SUBJECT: CLASSIFICATION OF HANFORD LOW-ACTIVITY TANK WASTE FRACTION

**REPORT ON  
DOE HANFORD TANK WASTE CLASSIFICATION**

**Nuclear Regulatory Commission  
Contract NRC-02-93-005**

**Center for Nuclear Waste Regulatory Analyses  
San Antonio, Texas**

Figure 2-1. Estimate Hanford Site Tank Waste Radionuclide Inventory<sup>cd</sup>

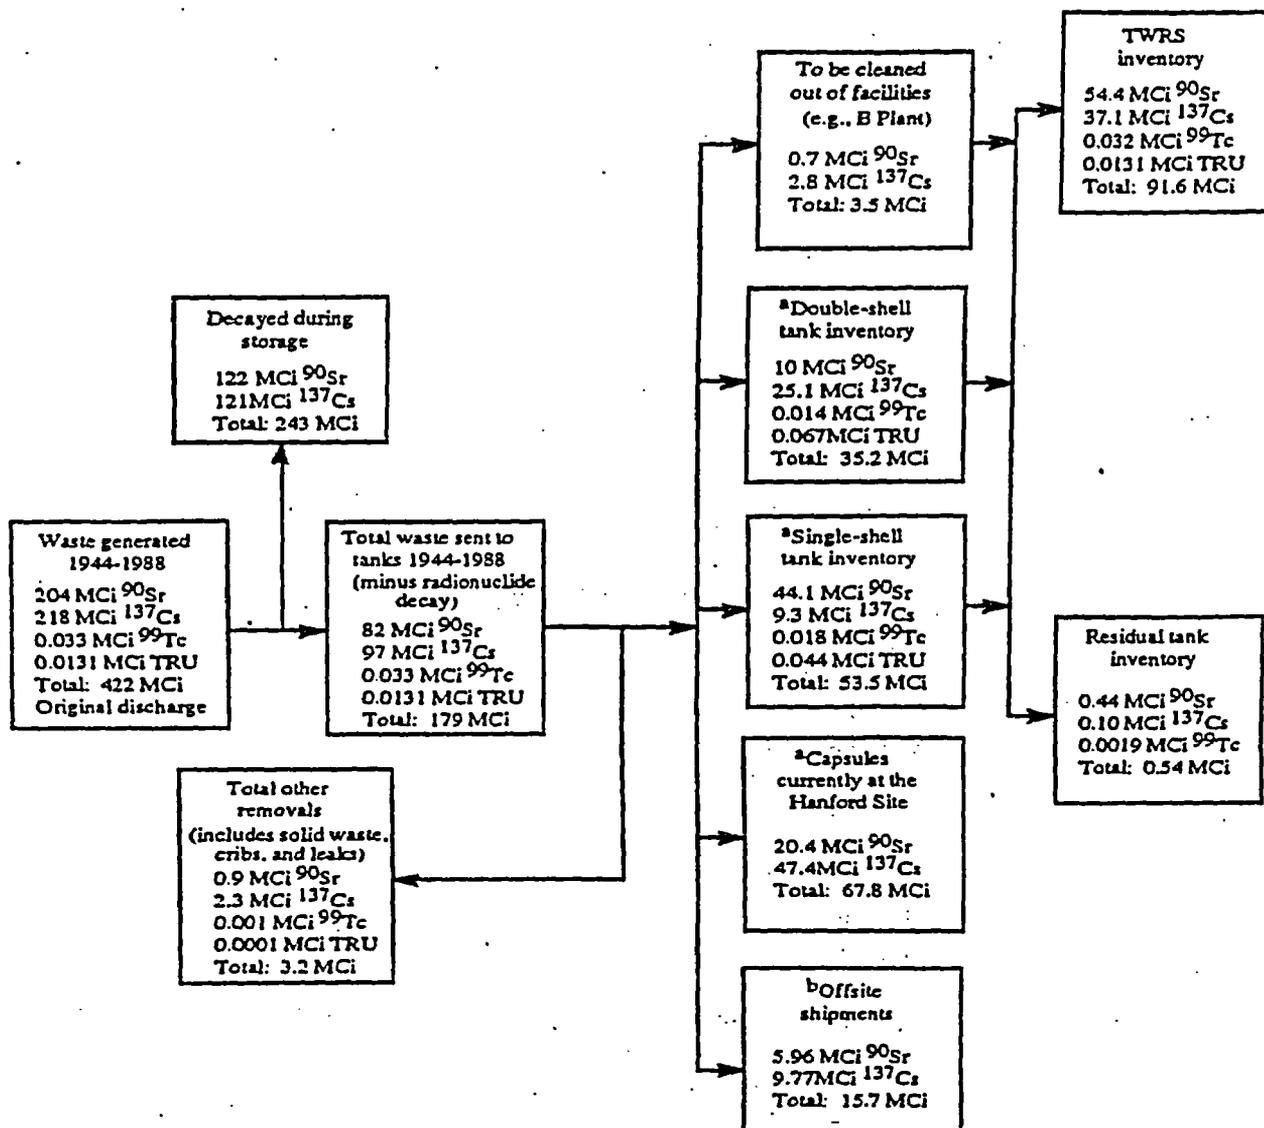
Figure 2-1, reproduced from the TBR (Westinghouse Hanford Company, 1996a, p. 3-2, figure 3-1), provides the estimated material balance for the Hanford Site tank waste radionuclide inventory. Figure 2-1 indicates that 243 MCi of the original tank waste radionuclide content of 422 MCi will have decayed by the year 1999. This value reflects the relatively short half lives of <sup>137</sup>Cs and <sup>90</sup>Sr. The material balance also indicates that approximately 87 MCi are accounted for as (i) leaks or deliberate discharges, (ii) encapsulation of <sup>137</sup>Cs and <sup>90</sup>Sr, (iii) other offsite shipments, or (iv) residual tank inventories. The remaining 91.6 MCi consists of 55.6 MCi insoluble waste to be disposed in a geologic repository as HLW and 36 MCi that comprises the soluble radionuclides that will be further treated to produce what DOE proposes to classify as incidental waste. This 36 MCi contains most of the <sup>137</sup>Cs and <sup>99</sup>Tc and almost all of the <sup>79</sup>Se, <sup>129</sup>I, <sup>14</sup>C, and <sup>3</sup>H (Westinghouse Hanford Company, 1996a, p. 4-1). After further treatment, 8.5 MCi will remain as incidental waste with 27.5 MCi being added to the HLW stream.

As shown in figure 2-1 of this report, 91.6 MCi comprises the Hanford Site tank waste inventory that will be processed for disposal as HLW or LLW. Approximately 99.9 percent of this waste is <sup>137</sup>Cs or <sup>90</sup>Sr. Initially, a simple solids-liquids separation will be performed on this waste to yield a low-activity liquid fraction containing the bulk of the nonradioactive materials, including about 3 percent solids carryover, and a high-activity fraction containing most of the solids. This solids-liquids separation process is expected to be relatively simple to complete and will remove approximately 55.6 MCi, consisting primarily of <sup>90</sup>Sr and TRU radionuclides (Westinghouse Hanford Company, 1996a, pp 3-2, 4-1, 4-2). Chapter 5 of the TBR concludes that, with the additional selective removal of transuranic wastes from three complexant concentrate tanks, and single-cycle ion exchange removal of <sup>137</sup>Cs from certain wastes,
